TITLE:- 4 LEAF RIGHT SIDE CRM DOOR 01/GATE 09

CLIENT - LESTECH
LOCATION - POSCO MANGAON
PRODUCT - SLIDING DOOR
DWG NO:-NIHVA/22-23/CLT/0014 REV- 1
SCALE: NTS SCALE:-- 1:1 SHEET: 01 OF 01

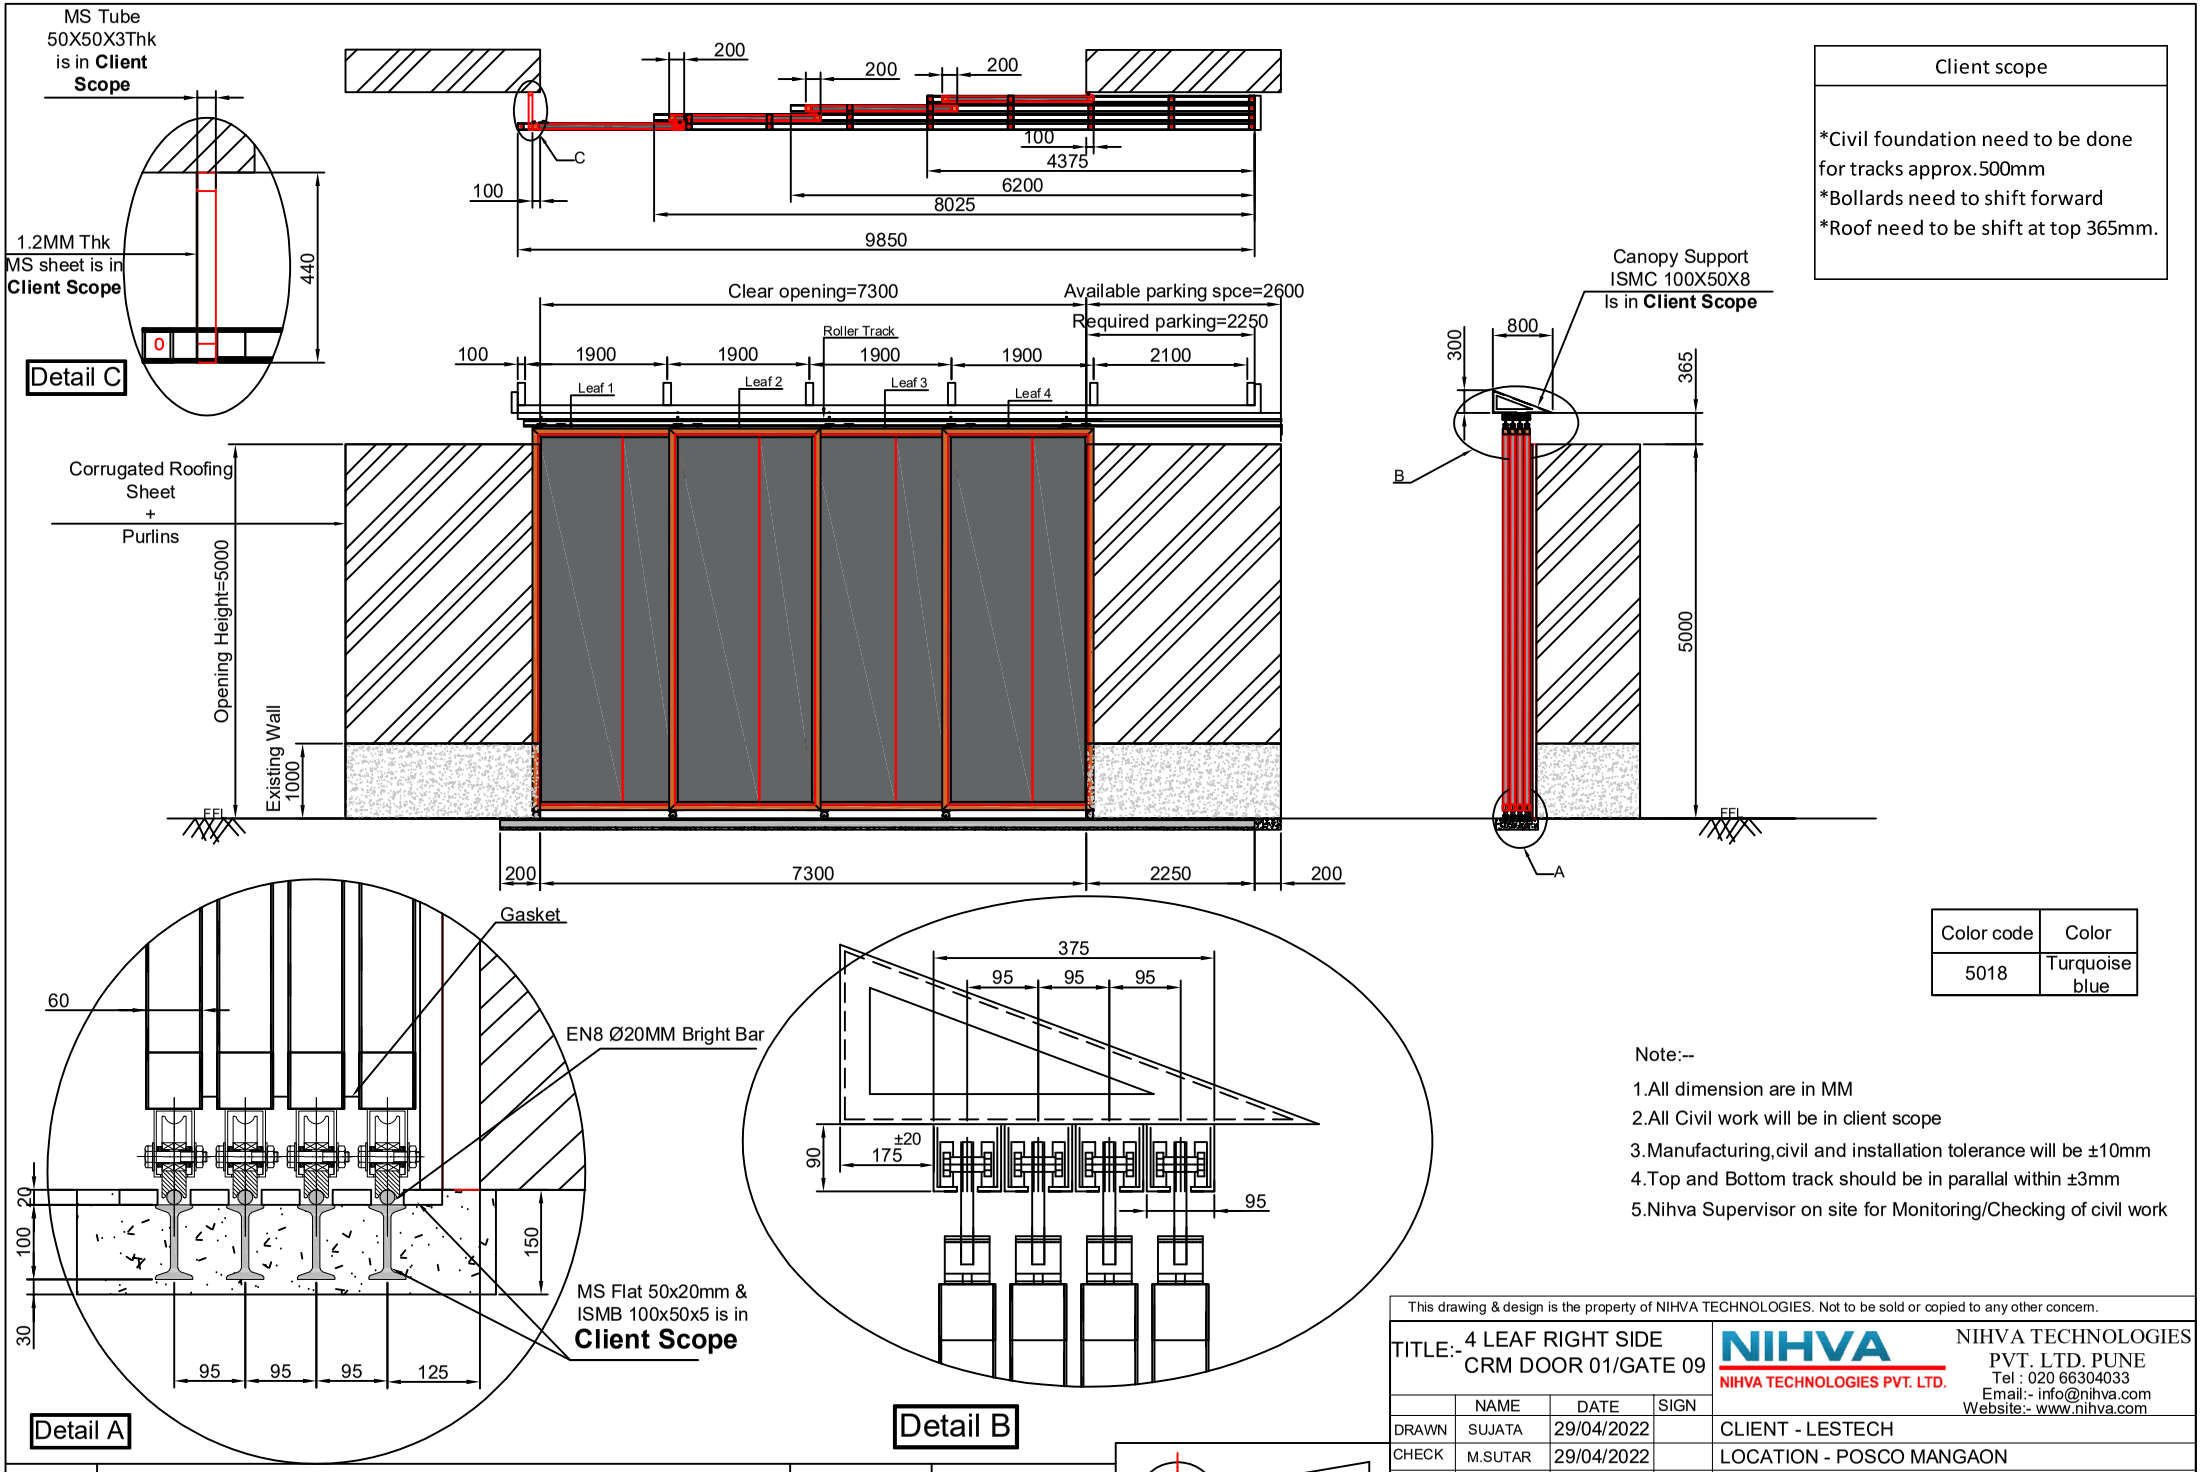
Client scope
*Civil foundation need to be done for tracks approx.500mm *Bollards need to shift forward *Roof need to be shift at top 365mm.
